# SERVICE BULLETIN No. 158

## Electro-Touch<sup>®</sup> Control with Adaptor Harness

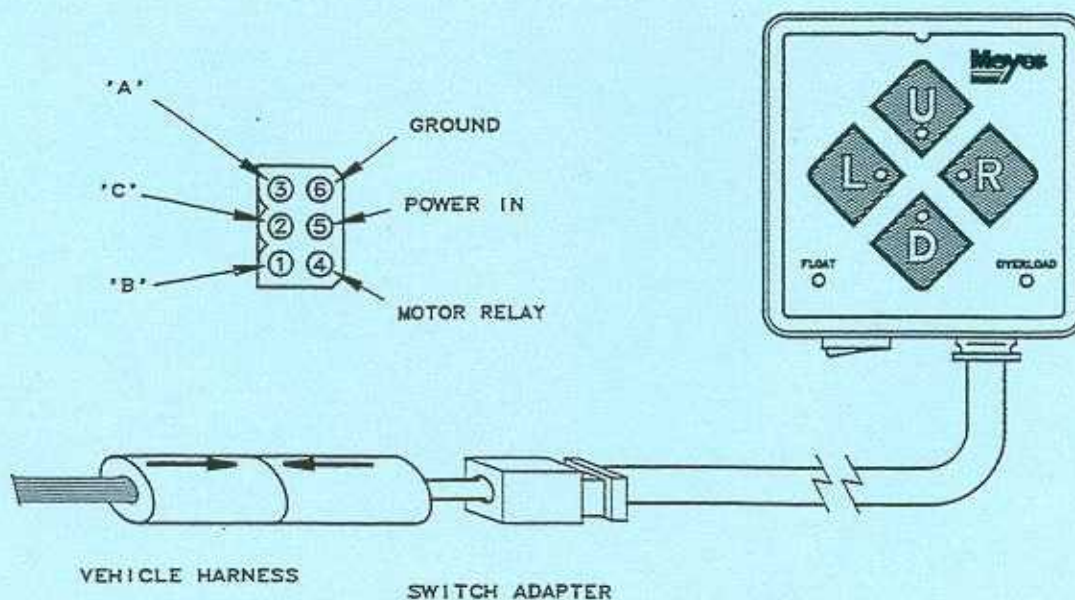
This is a Service replacement Kit for the Electro-Touch<sup>®</sup> Control Part No. 22125.

The new control harness is not compatible with the existing Harness and Fuse Assembly (15725). Therefore an Adaptor Harness (15766) has been provided for quick switch replacement without having to replace the main control harness.

**CAUTION** should be used when plugging Adaptor Harness (15766) into harness (15725). Both Male and Female ends have alignment tabs and arrows → ← to insure proper installation. Plug the new control (22154) into adaptor harness (15766). Install the two strips of Velcro tape to the mounting bracket. Attach switch control to bracket making sure that control harness is up and out of the way.
